**Re: Peer Review Response
91 Beatrice Circle
Belmont, MA**

DeCelle-Burke-Sala & Associates, Inc. (DBS) has prepared the attached information to respond to outstanding concerns raised by your peer review professional, Jesse Johnson, PE of Weston & Sampson Engineers, Inc. (W&S) during recent work sessions and as outlined in an email dated June 16, 2021 and another email dated July 6, 2021. The outstanding bulleted and numbered concerns itemized in the emails with corresponding responses underneath are as follows:

June 16, 2021 Email

July 6, 2021 Email

SHEET 8 OF 11

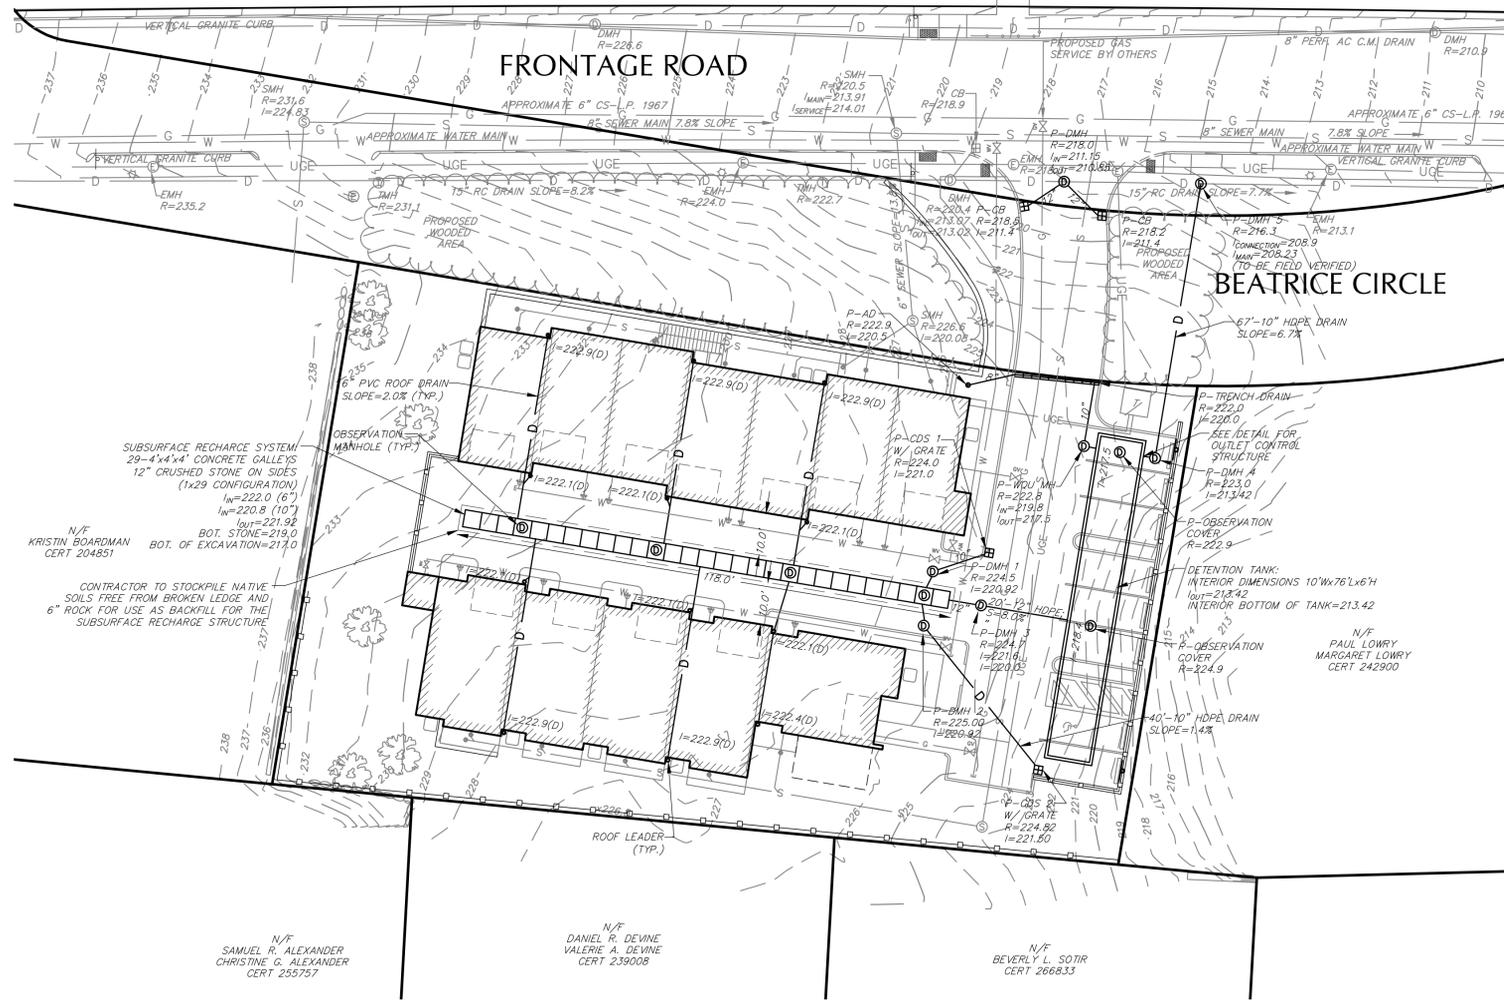
7. Typical trench drain / area drain detail included on Sheet 8 of the dwgs. Specific elevations should be provided to confirm the system will work as designed.

The trench drain and area drain were revised to include some minimal dimensions.

4'x4'x4' CONCRETE LEACHING GALLEY STRUCTURE
NOT TO SCALE

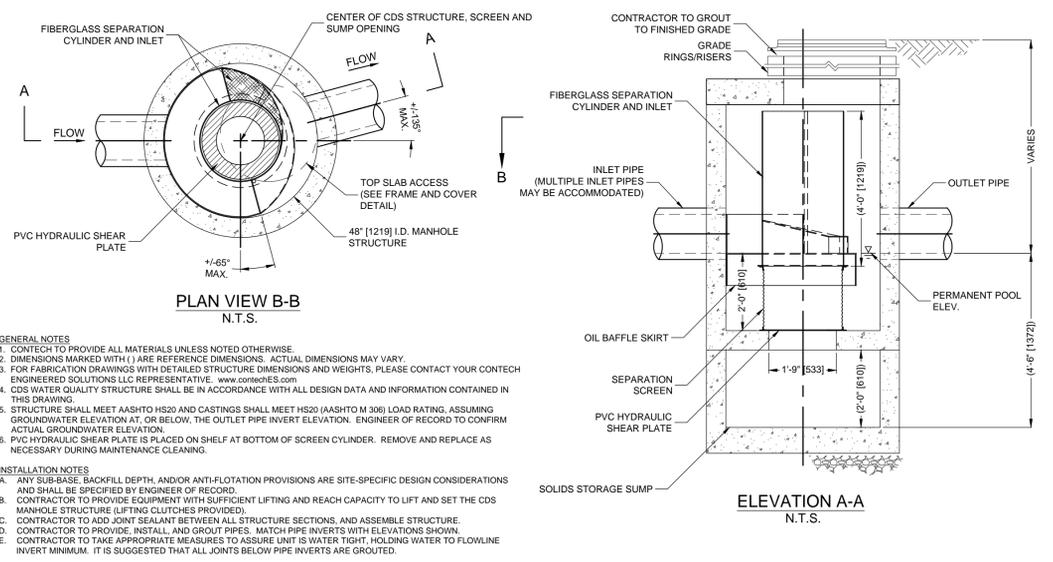
6. Drawings reference 4x4x3 galley structure. HydroCAD uses 4x4x4.

The plans were revised to correlate with the HydroCAD calculations and reference the 4x4x4 galleys.

LANDSCAPE PLAN
 91 BEATRICE CIRCLE
 BELMONT, MA

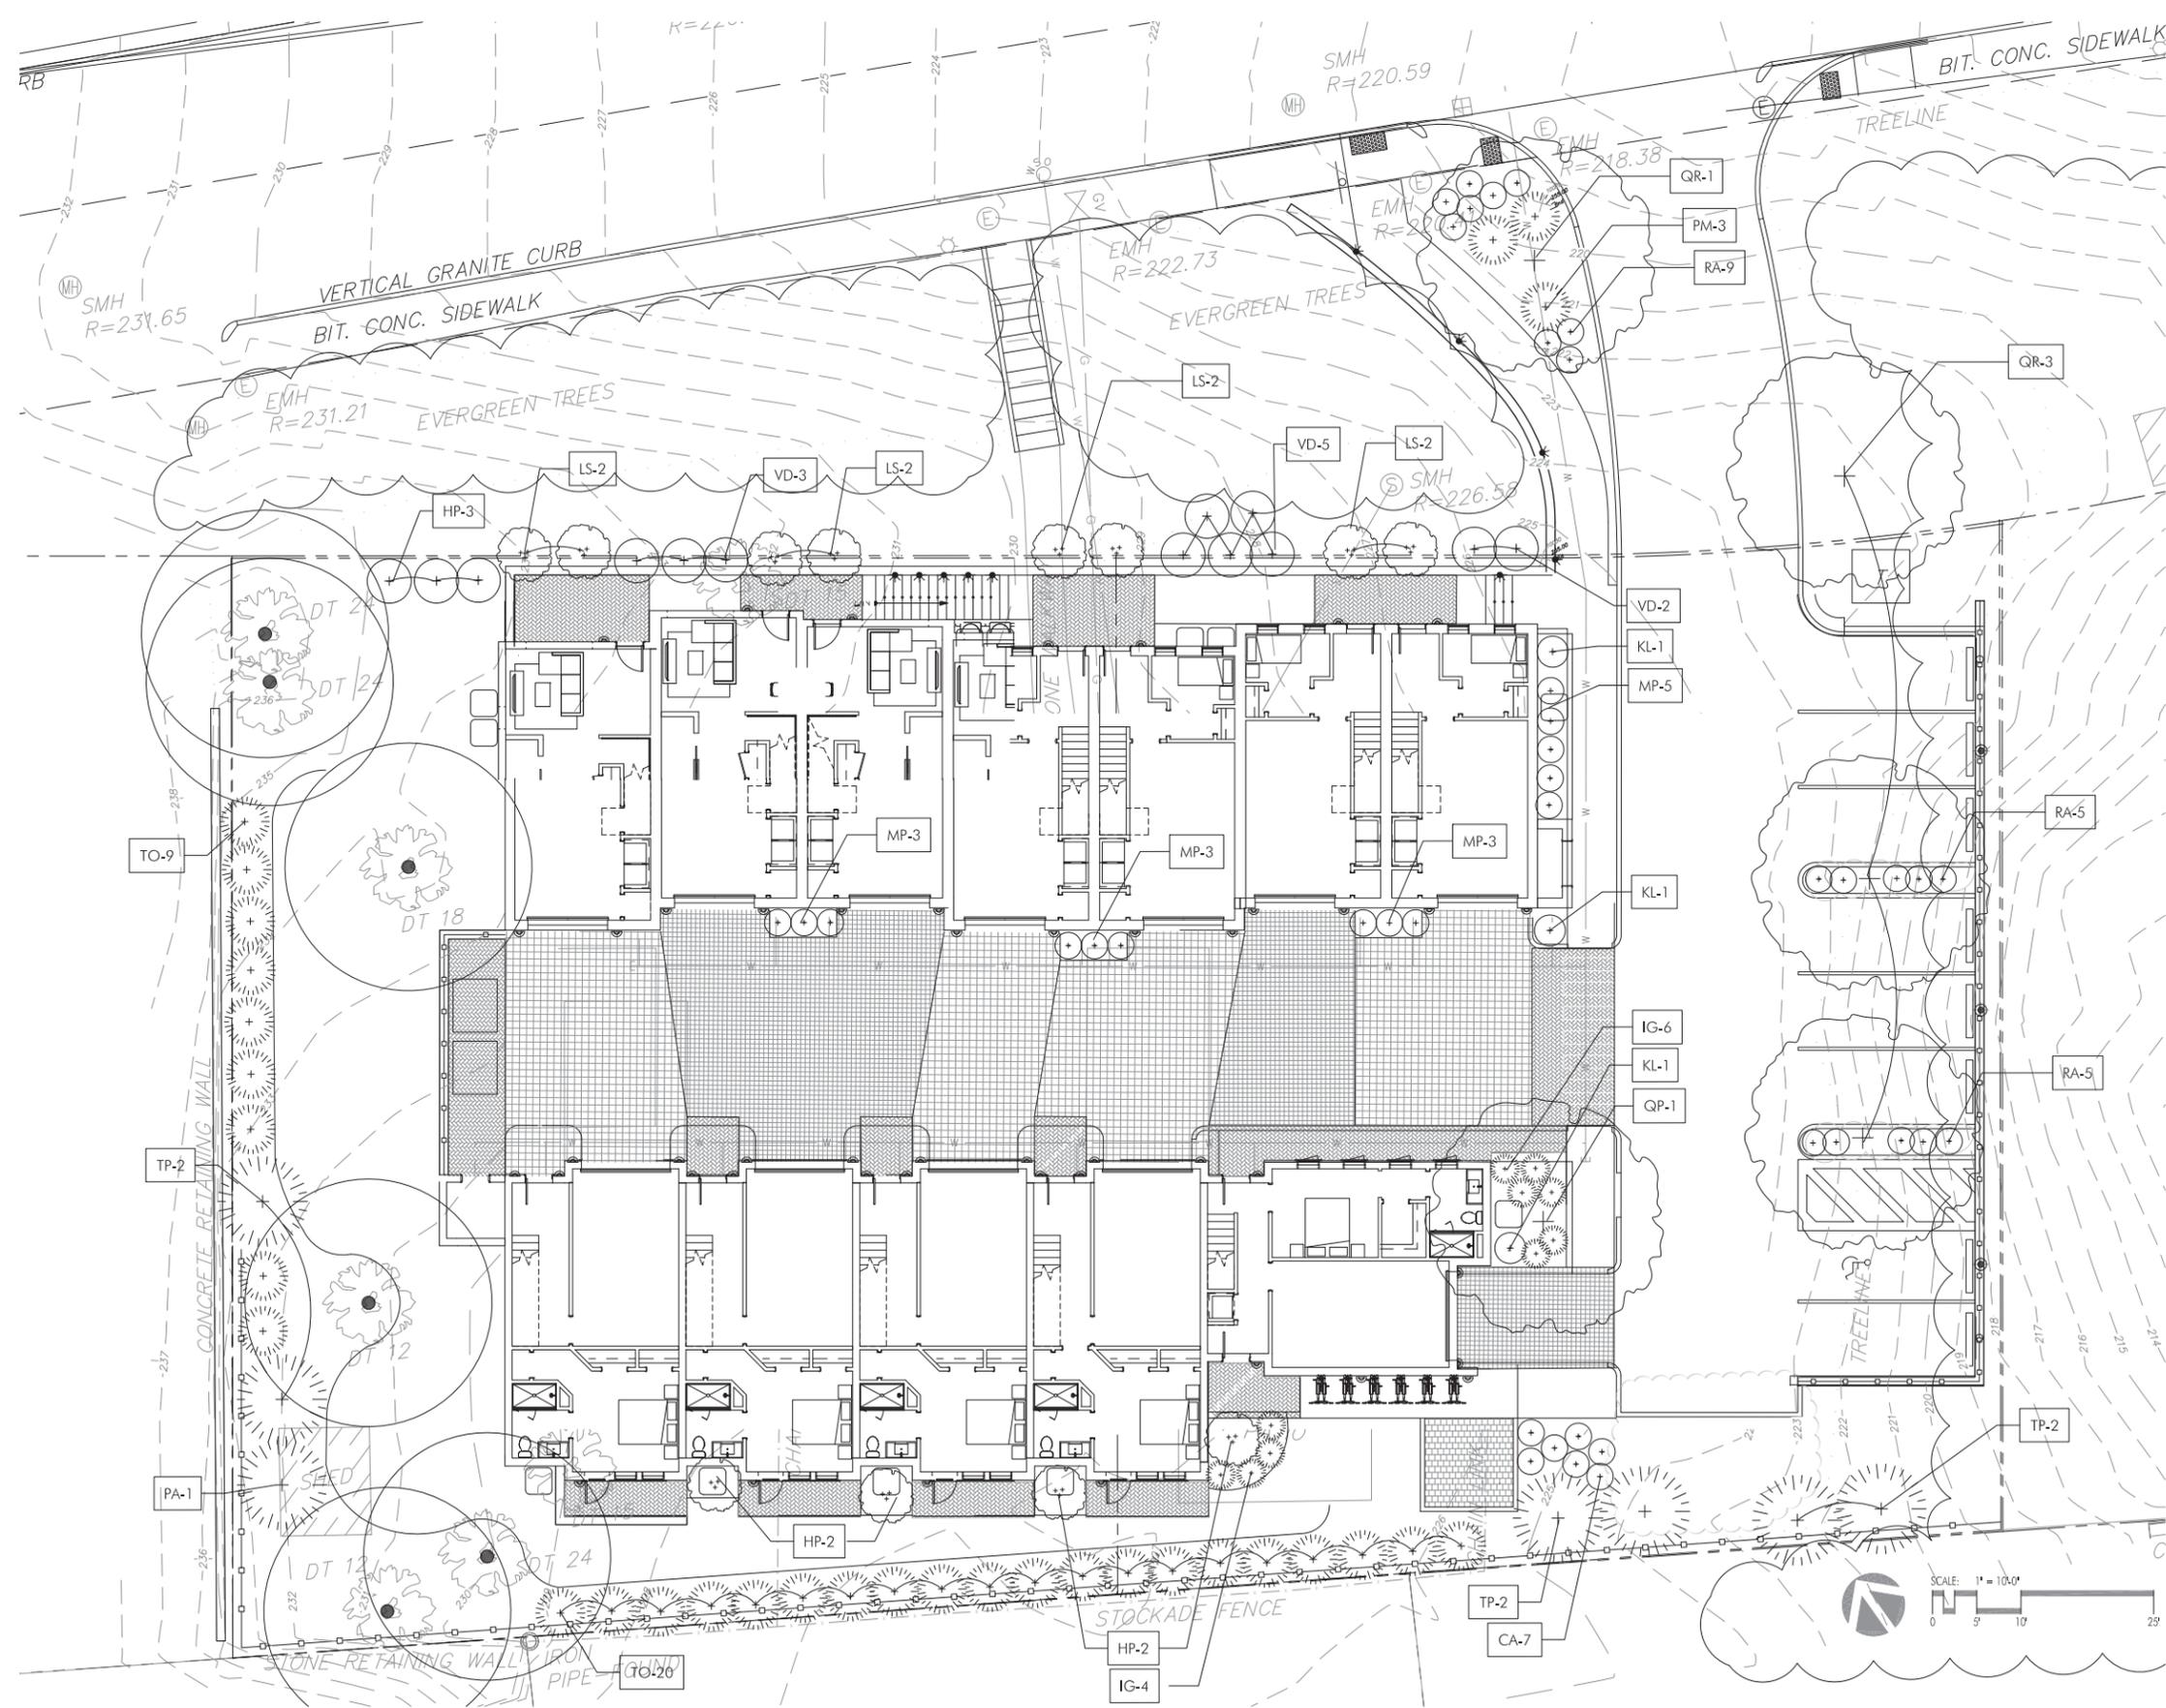
8. Proposed snow storage areas identified in parking medians. Landscape plans have plantings here. Confirm / update snow storage areas.

It is our understanding that the snow areas shall be landscaped.
